Product Change Notice (PCN)

PCN Number: PCN-0451201R-01

Product(s) Affected: PJ-056, PJ-035-SMT-TR

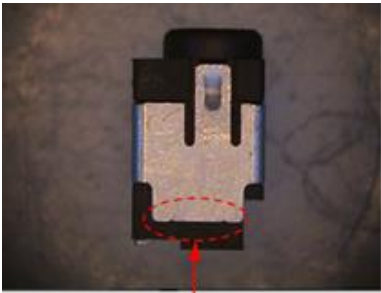
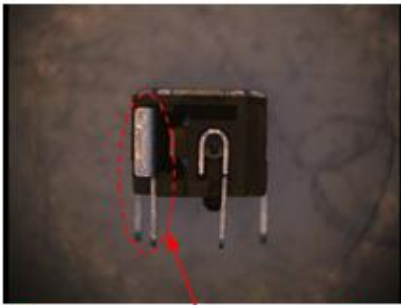
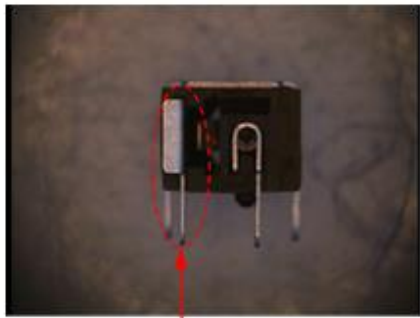
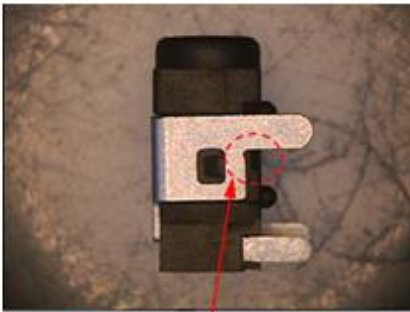
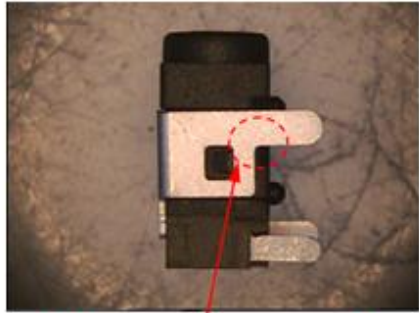
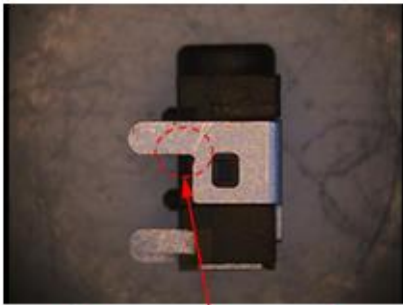
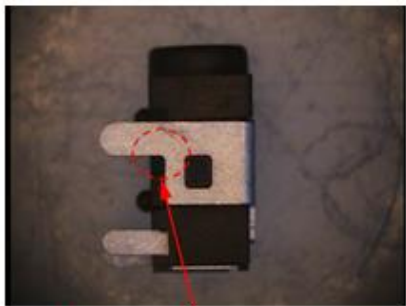
New version	Current version
Top	 <p>pin#3 marking at the back</p>	 <p>pin#3 marking on sides</p>
Back	 <p>thickness of pin#2 is 0.25mm</p>	 <p>thickness of pin#2 is 0.2mm</p>
Left	 <p>pin#3 with dent</p>	 <p>pin#3 without dent</p>
Right	 <p>pin# 3 with dent</p>	 <p>pin#3 without dent</p>

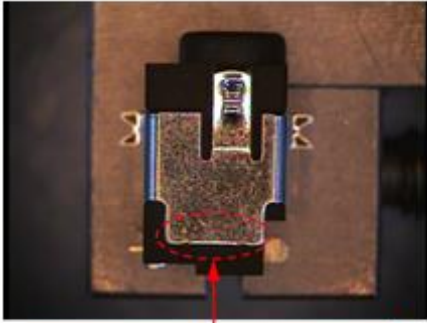
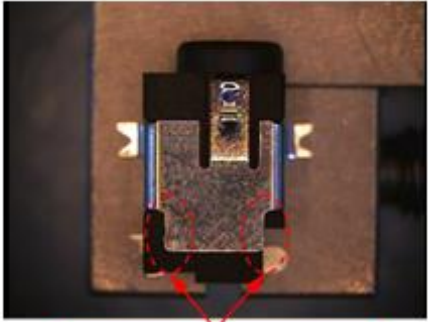
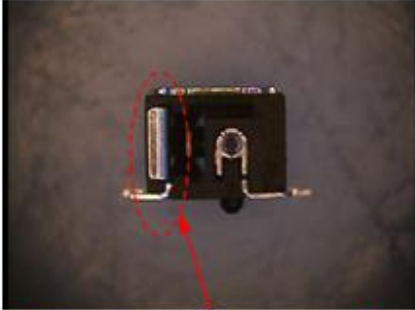
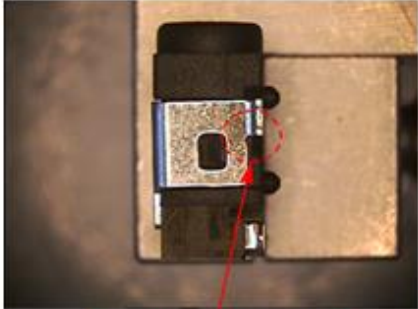
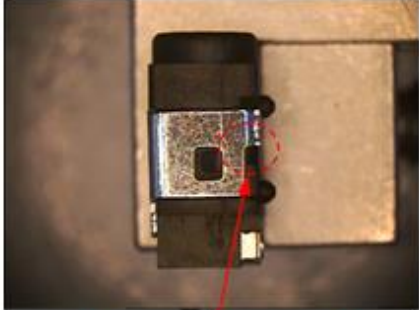
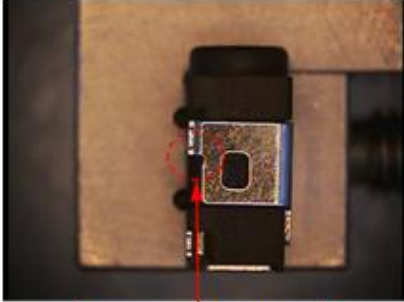
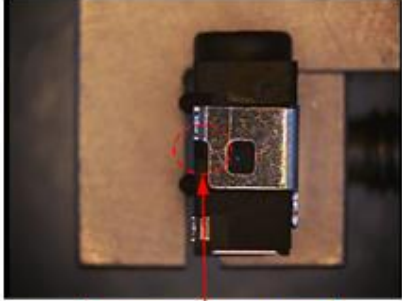
New version	Current version
Top	 <p data-bbox="358 489 721 541">pin#3 marking at the back</p>	 <p data-bbox="1013 489 1312 541">pin#3 marking on sides</p>
Back	 <p data-bbox="358 915 721 968">thickness of pin#2 is 0.25mm</p>	 <p data-bbox="997 915 1330 968">thickness of pin#2 is 0.2mm</p>
Left	 <p data-bbox="428 1346 680 1398">pin#3 with dent</p>	 <p data-bbox="1036 1346 1287 1398">pin#3 without dent</p>
Right	 <p data-bbox="415 1757 662 1801">pin#3 with dent</p>	 <p data-bbox="1040 1757 1281 1801">pin#3 without dent</p>
